STAFF REPORT: NOVEMBER 8, 2023 MEETING

APPLICATION NUMBER: HDC2023-00072

ADDRESS: 7908 – 7912 ST. PAUL

SCOPE: REMOVE WOOD SIDING (WORK COMPLETED WITHOUT APPROVAL), INSTALL WOOD SIDING, REPAIR/REPLACE WINDOWS

Applicant drawing.

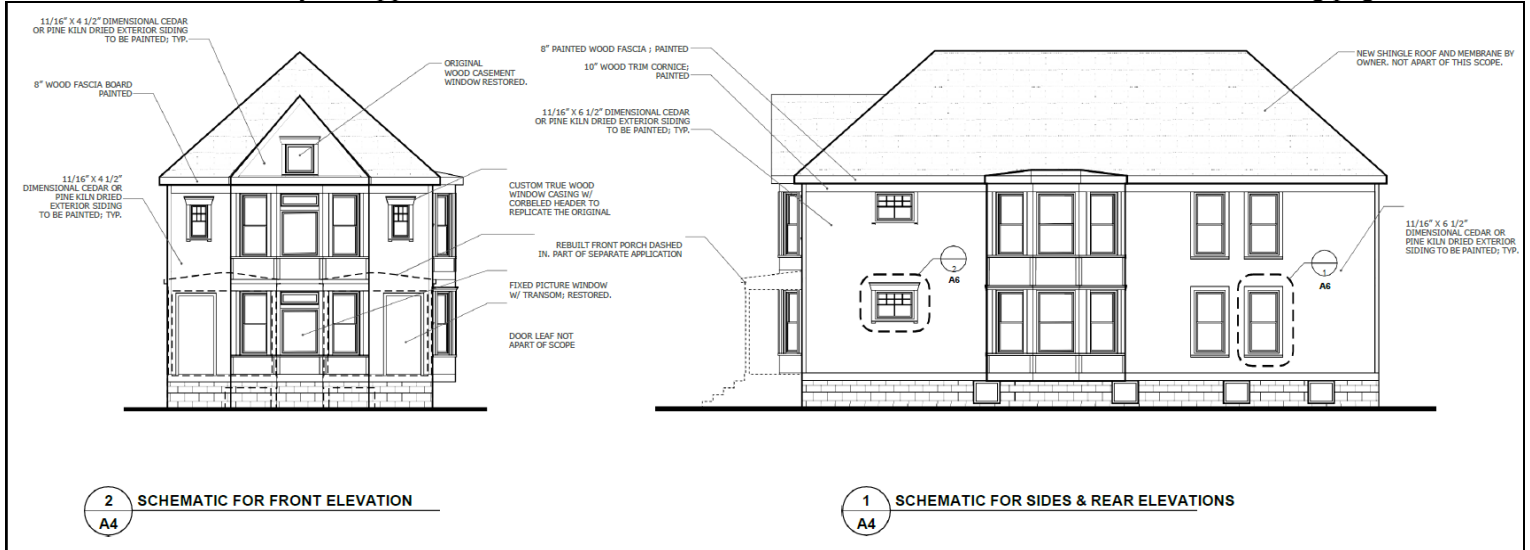
- The current application proposes to install new wood clapboard siding on each elevation. The front elevation's siding will have a three-inch exposure and the side and rear elevations' siding will have a five-inch exposure, similar to what is shown in the May 2019 photograph on the preceding page.

Applicant drawings.

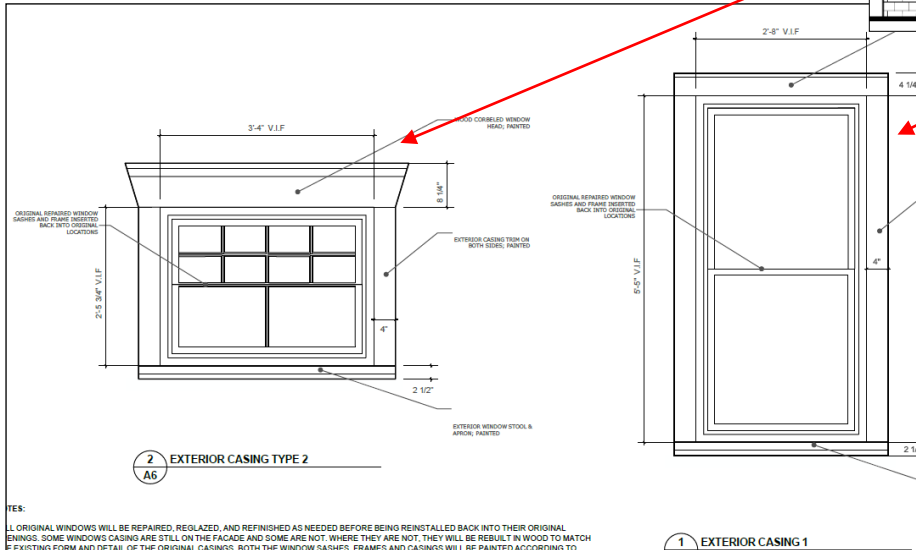
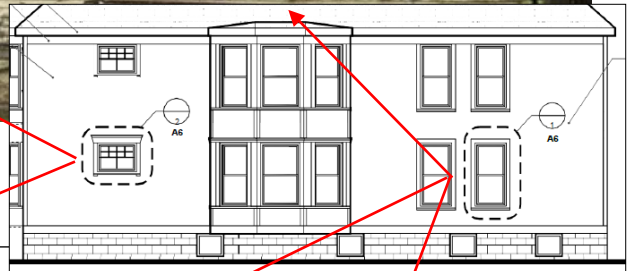
- The drawings show window casings will be constructed in a similar way to the historic condition.

Above: Staff photo. Right: Applicant drawing.

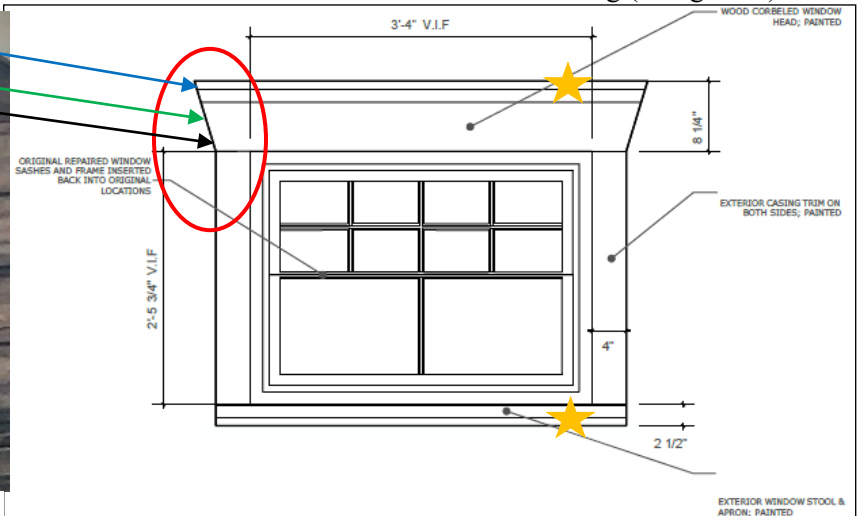
- The drawing for the window casing for the small windows is not drawn accurately: it doesn't show the trim directly above the window opening (black arrow), the flat trim is shown to angle outward (green arrow) rather than only the decorative trim above the casing extending outward on an angle (blue arrow). Additionally, the protruding dimension for the sill and the header's decorative trim isn't noted on either drawing (orange star).

- Elevation drawings for the east and south elevations will be created and will document all related scope of work (including trim, wall, and porch details).
- The window casing drawings will be corrected to accurately reflect the existing conditions and dimensions.
- The front elevation drawing will be revised to include notations of the retention of trim within and below the gable.
- A site plan will be submitted to confirm placement and dimensions of rear stairwell (if one is being erected).
- Manufacturer’s or fabricator’s information, including sash dimensions, for the new wood windows will be submitted. The elevation drawings will note the window openings that will receive new window sash.
- Revised plans noting all the above conditions will be submitted for staff review prior to pulling a permit.
